Contract No. T201507602.01

BR 3-154 on US9 Savannah Road and BR 3-153 on SR1 Rehoboth Avenue over Lewes-Rehoboth Canal
Sussex County

Enclosed is Addendum No. 3 for the referenced contract consisting of the following:

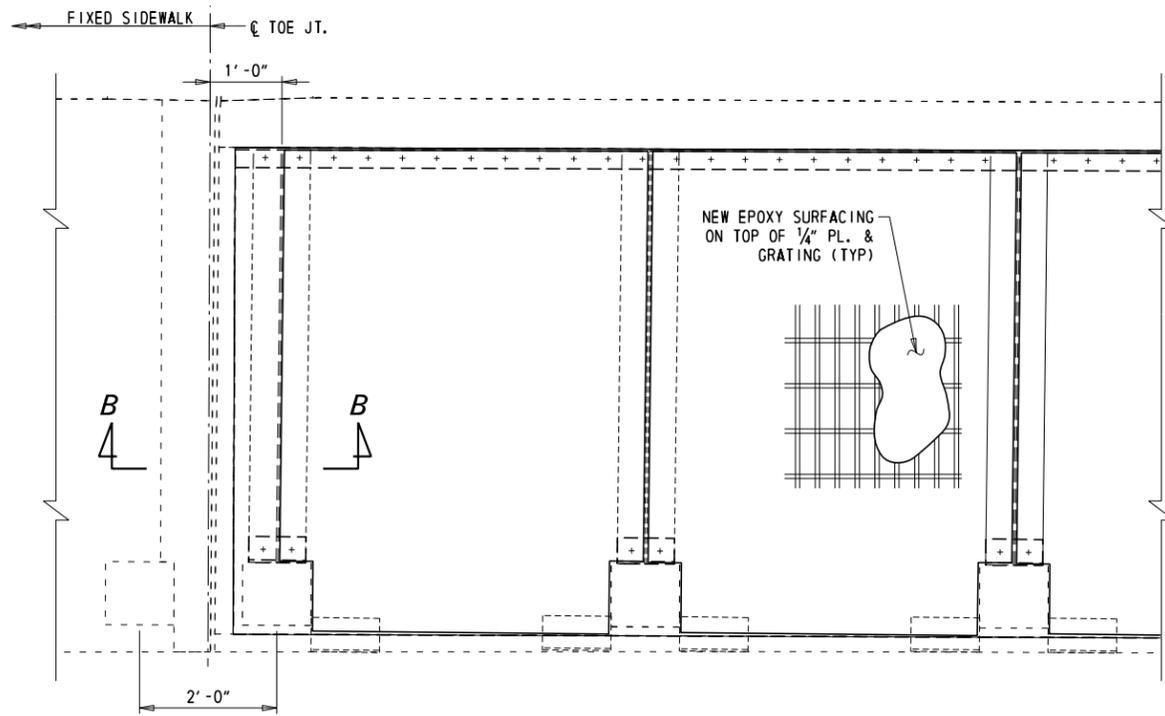
*REPAIR QUANTITIES FOR THESE ITEM NUMBERS HAVE BEEN INCREASED BY 30% OVER THE QUANTITIES MEASURED DURING THE BRIDGE INSPECTIONS THAT BEGAN ON MAY 18, 2015. PAYMENT WILL BE BASED UPON THE ACTUAL QUANTITIES REQUIRED TO COMPLETE THE REPAIRS.

~~**REPAIR QUANTITIES FOR THESE ITEM NUMBERS HAVE BEEN INCREASED BY 10% OVER THE QUANTITIES MEASURED DURING THE BRIDGE INSPECTIONS THAT BEGAN ON MAY 18, 2015. PAYMENT WILL BE BASED UPON THE ACTUAL QUANTITIES REQUIRED TO COMPLETE THE REPAIRS.~~

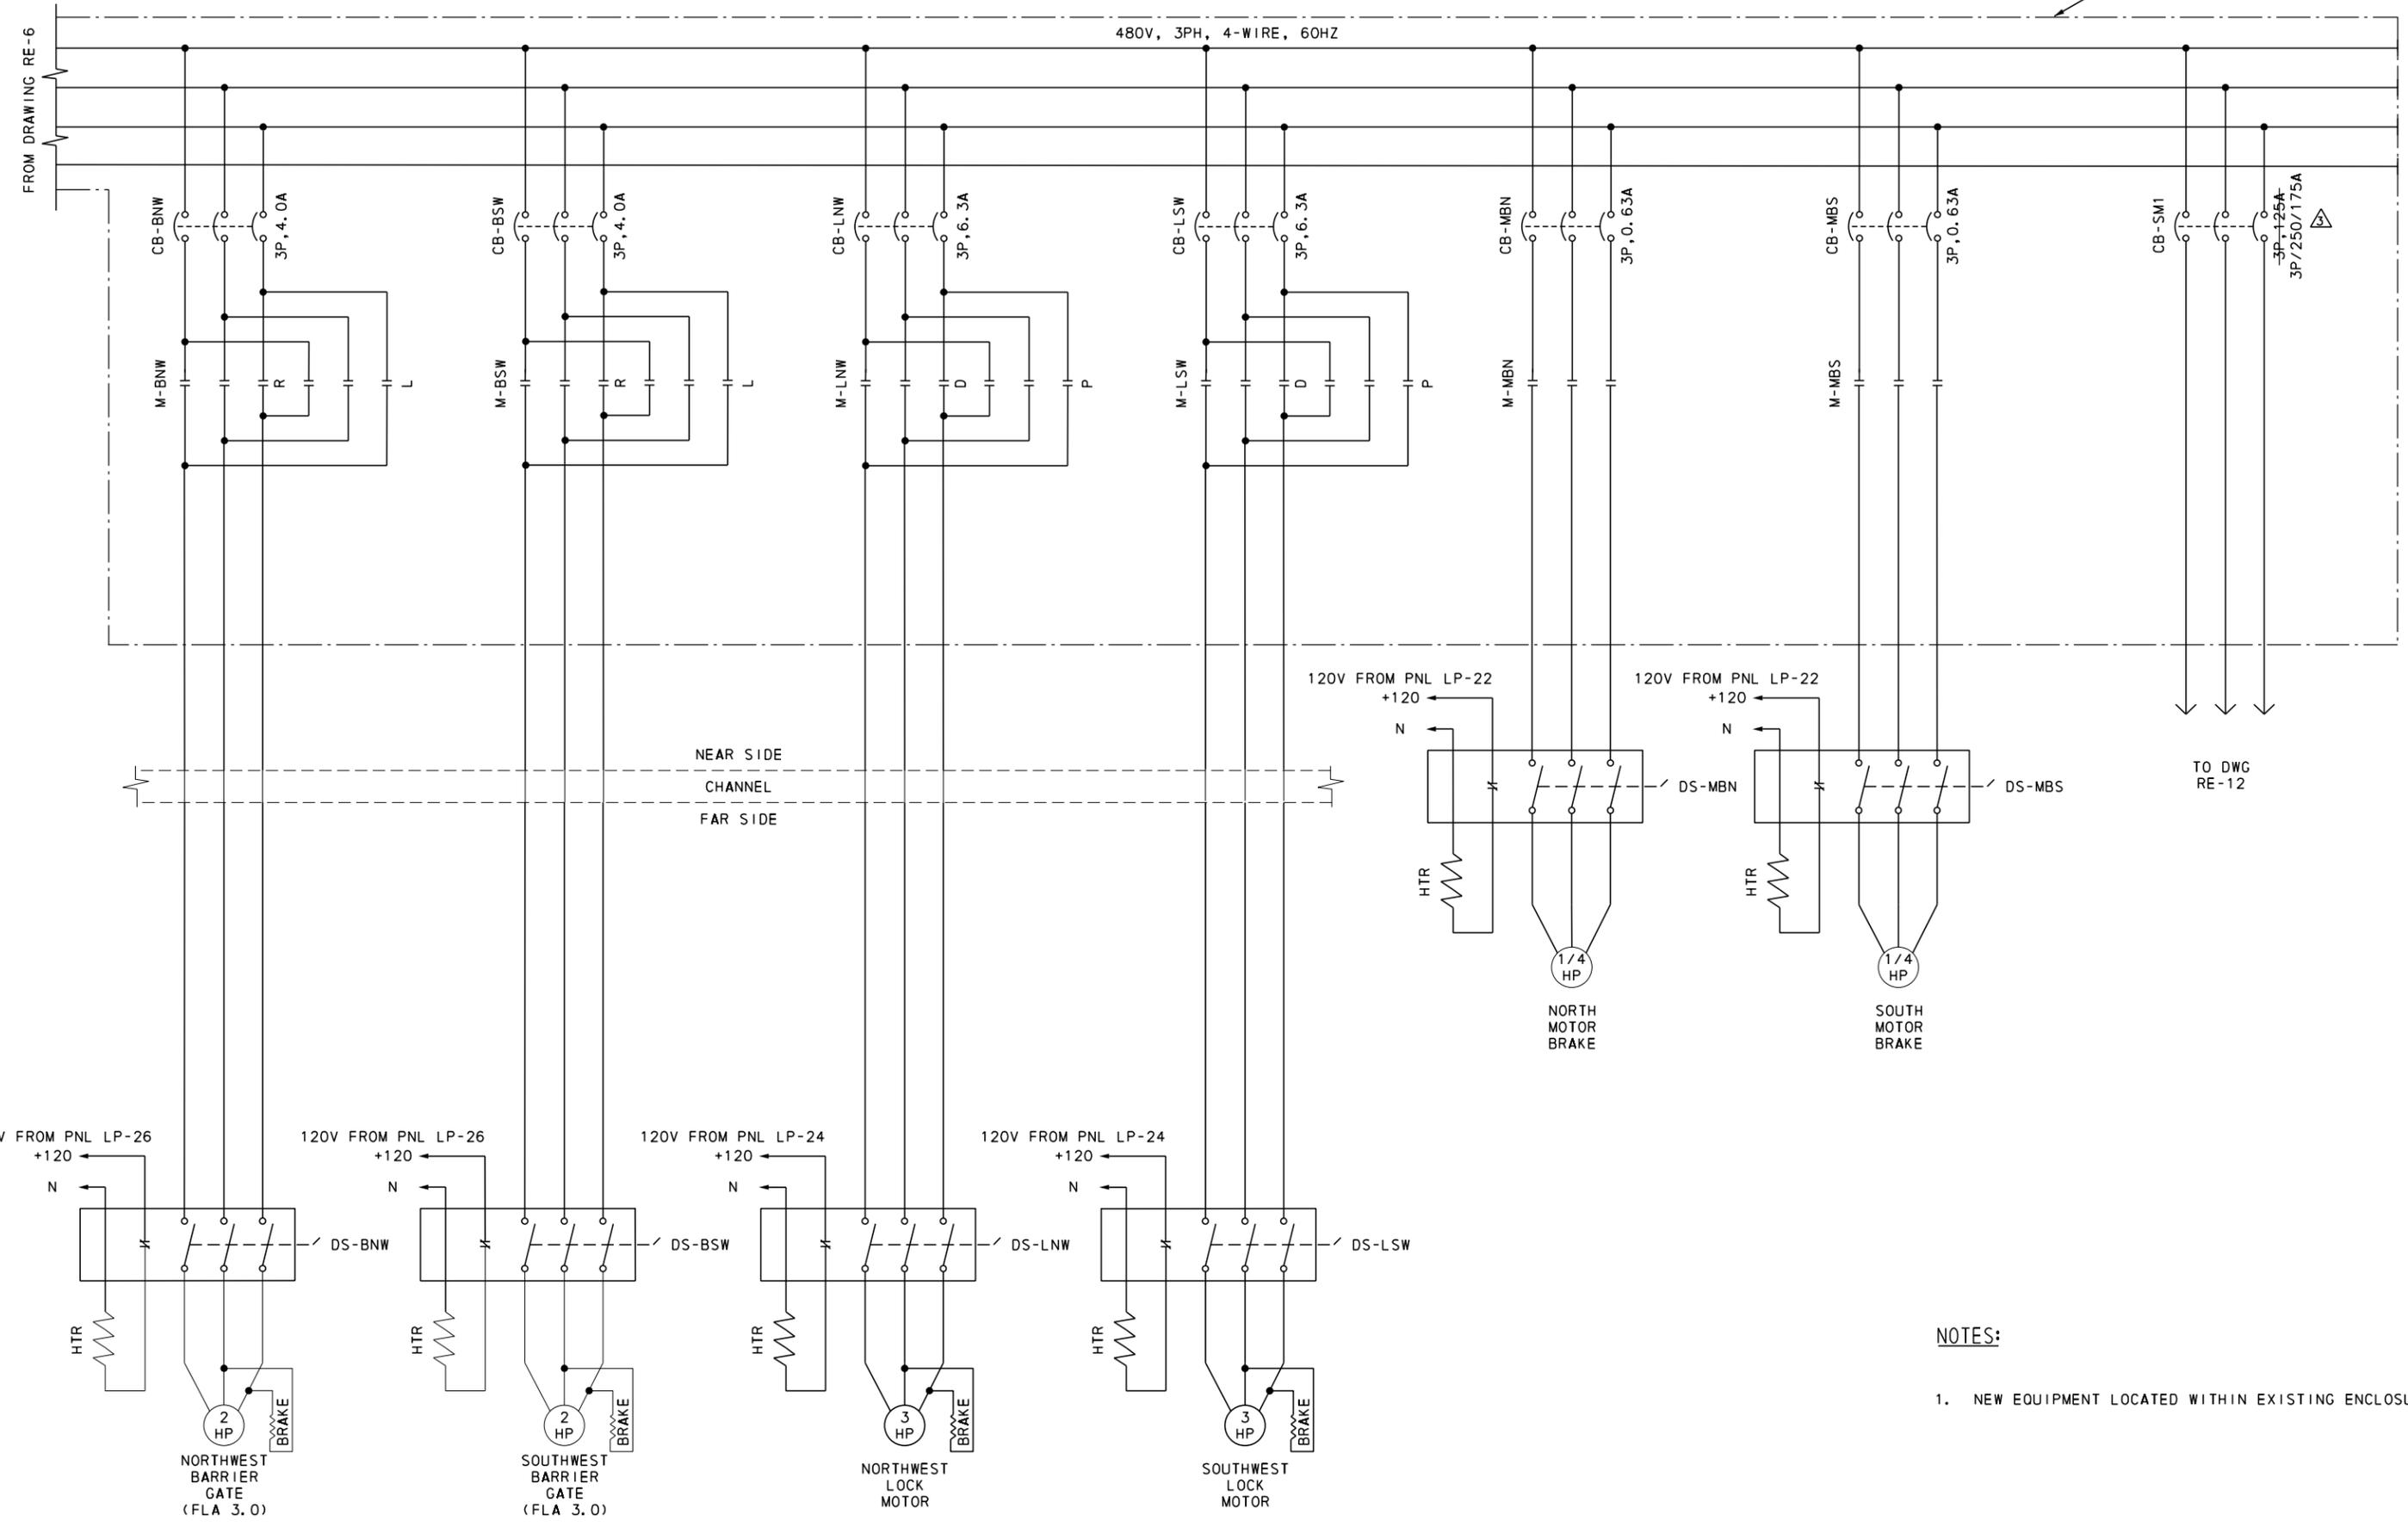
- CONTRACTOR TO ADJUST THE EXISTING CB SETTING TO MATCH THE GENERATOR NAMEPLATE CURRENT AT 480 VAC AND ADD AUXILIARY CONTACTS.
 - FURNISH AND INSTALL NEW FUEL LEVEL SENSORS AND ALARMS IN EXISTING TANK CONNECT SENSORS TO PLC AND GENERATOR AS REQUIRED.

ADDENDUMS / REVISIONS △ MODIFIED CIRCUIT BREAKER SETTING (MJT 7/23/18)	NOT TO SCALE	BR 3-154 ON US9 SAVANNAH ROAD & BR 3-153 ON SR1A REHOBOTH AVENUE OVER LEWES-REHOBOTH CANAL	CONTRACT T201507602	BRIDGE NO. 3-153	THREE LINE DIAGRAM I	RE-5
	COUNTY SUSSEX			DESIGNED BY: MJT CHECKED BY: AHN	SHEET NO. 42		
TOTAL SHTS. 180

SPAN DRIVE CONTROLS	
RE-12	SHEET NO.
	49
	TOTAL SHTS.
	180

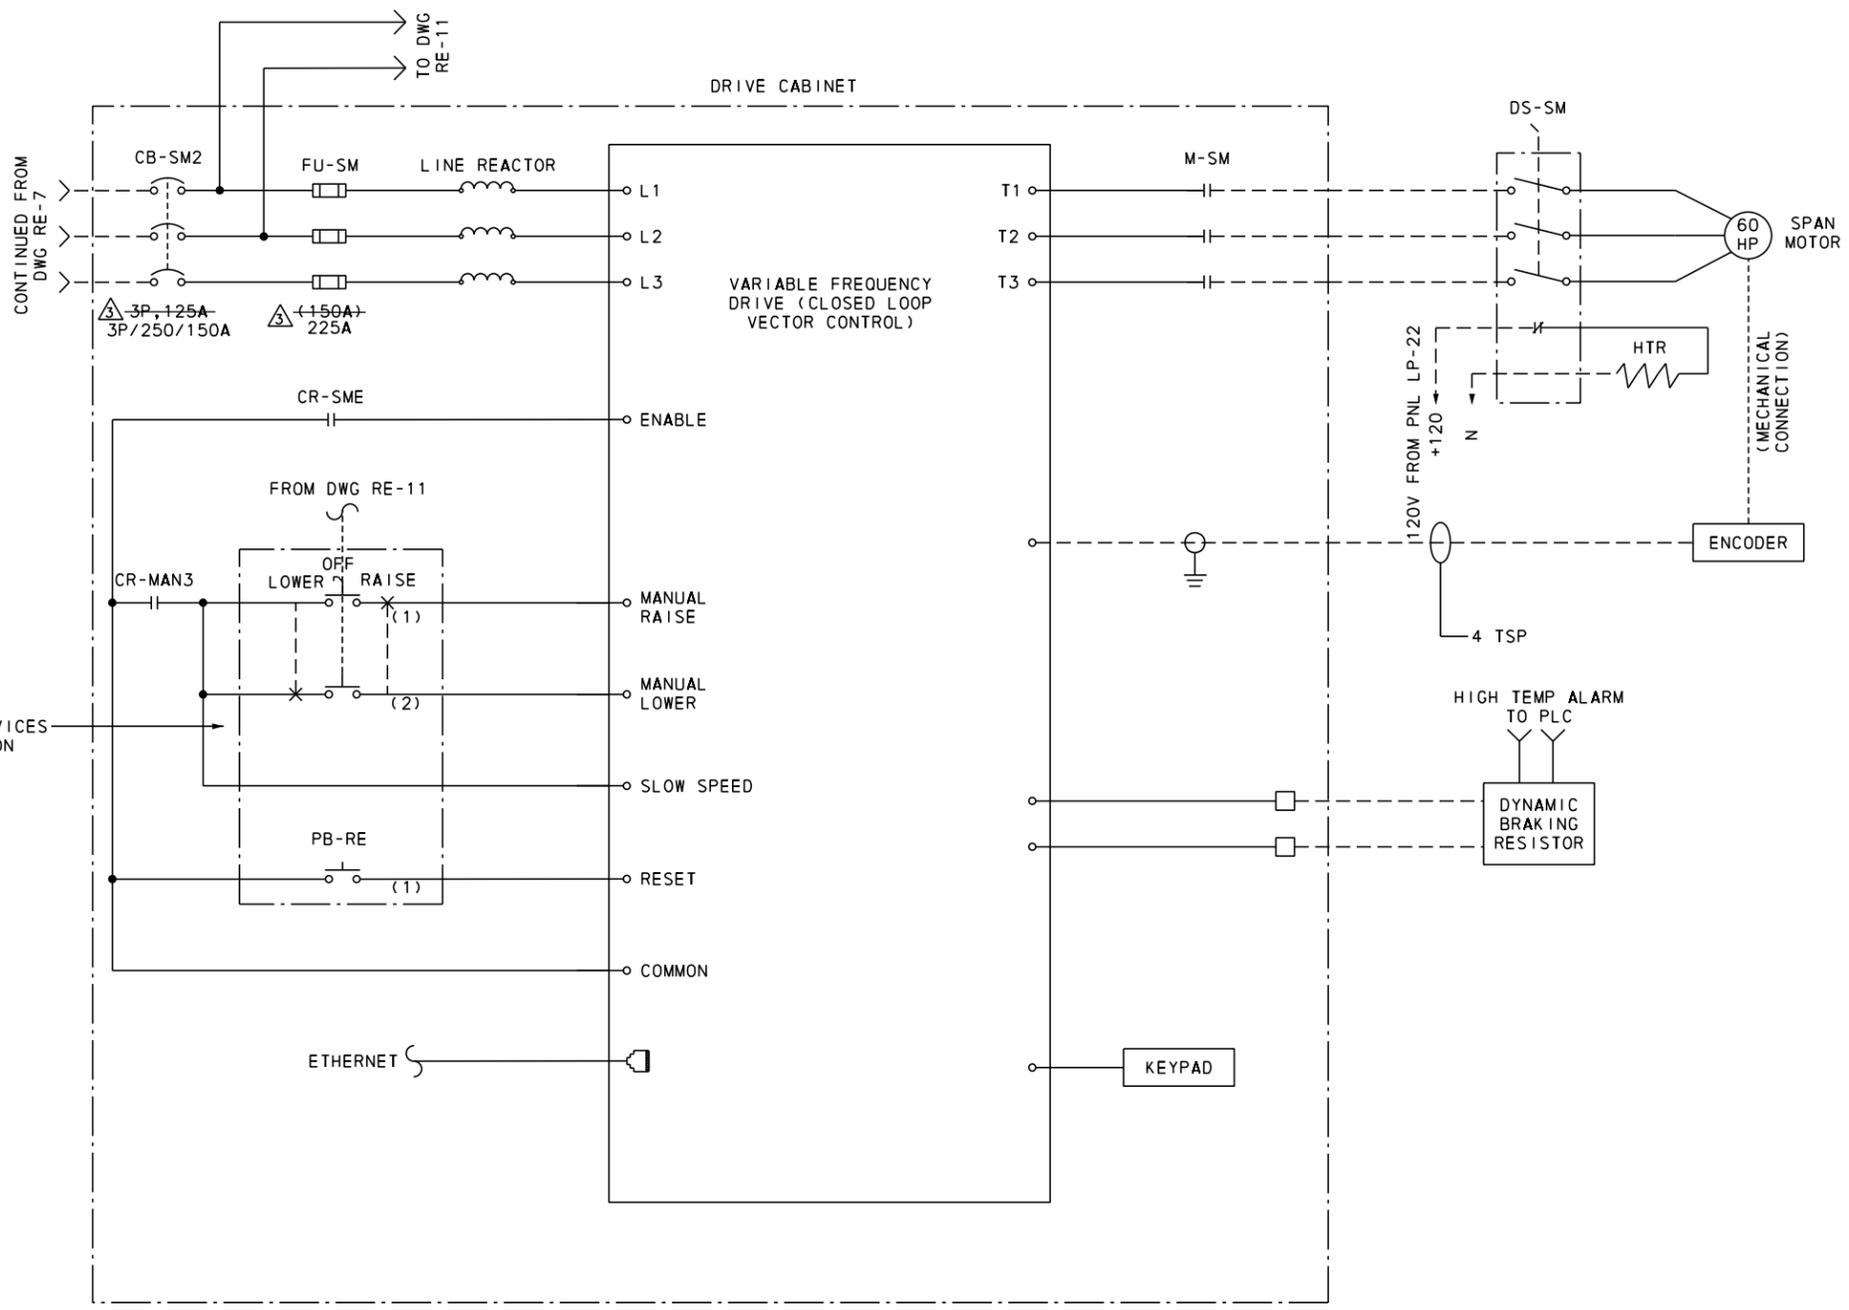
1. CIRCUIT BREAKER AND FUSE SIZES SHALL BE MODIFIED PER MANUFACTURER RECOMENDATIONS.
2. WIRING TO AND FROM RESISTOR ENCLOSURE SHALL BE HIGH TEMP WIRE.

ADDENDUMS / REVISIONS	
△	MODIFIED CIRCUIT BREAKER/FUSE SETTING (MJT 7/23/18)

RE-24
SHEET NO.
61
TOTAL SHTS.
180

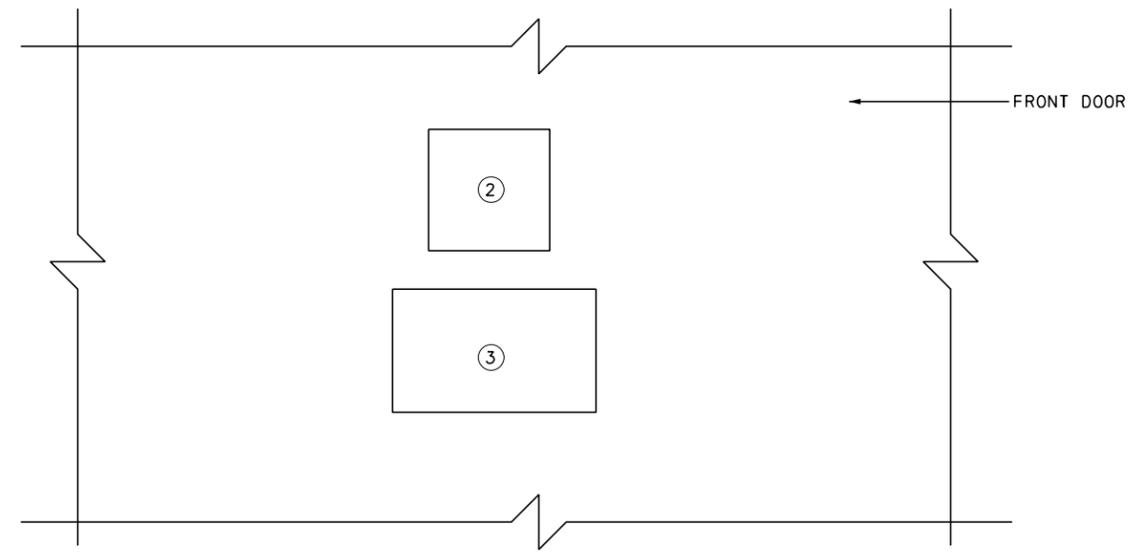
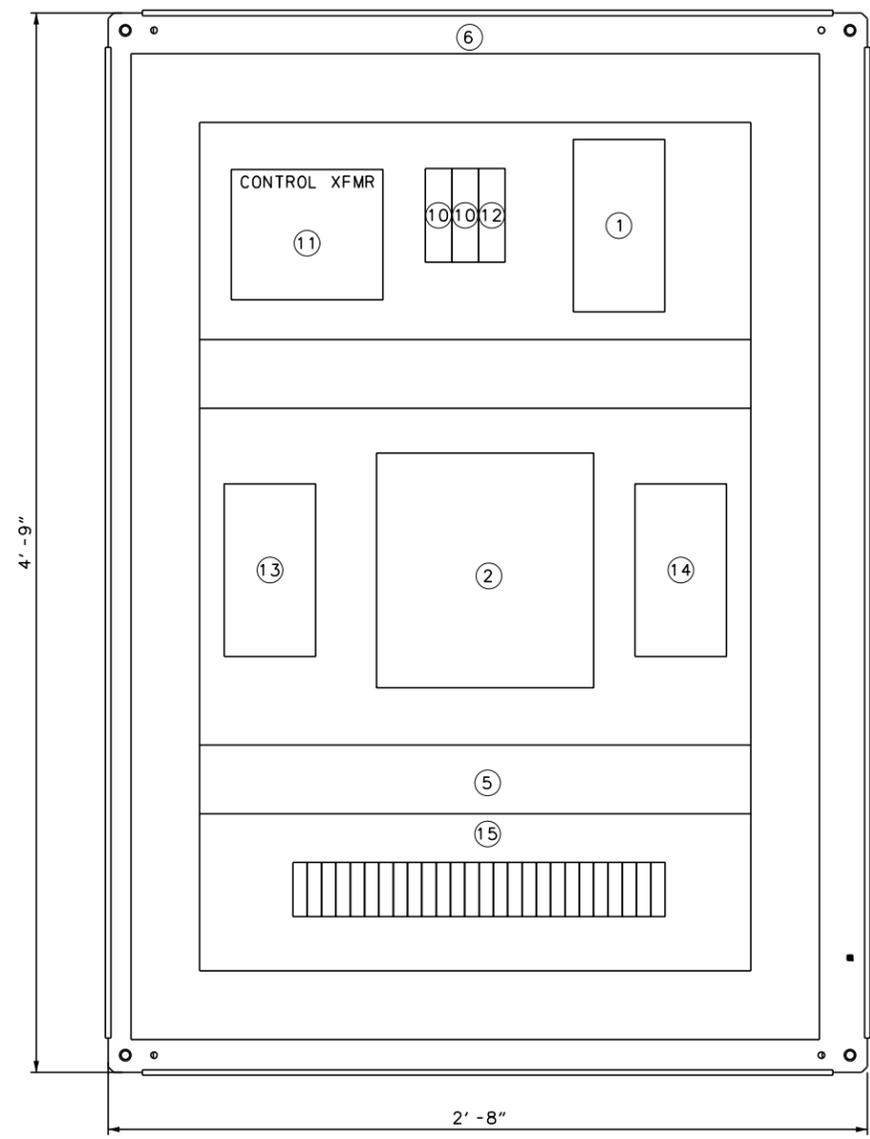
^Δ 3P, 600V, 125AF/60AT, 35KAIC
^Δ 3P, 600V, 125AF/75AT, 35KAIC

- ALTERNATE MANUFACTURER SUBSTITUTIONS FOR SQUARE D EQUIPMENT AND COMPONENTS SHOWN IN THE PLANS AND SPECIFIED IN THE SPECIAL PROVISIONS SHALL NOT BE PERMITTED.

ADDENDUMS / REVISIONS	
^Δ	MODIFIED BILL OF MATERIALS & NOTES (MJT 7/23/18)
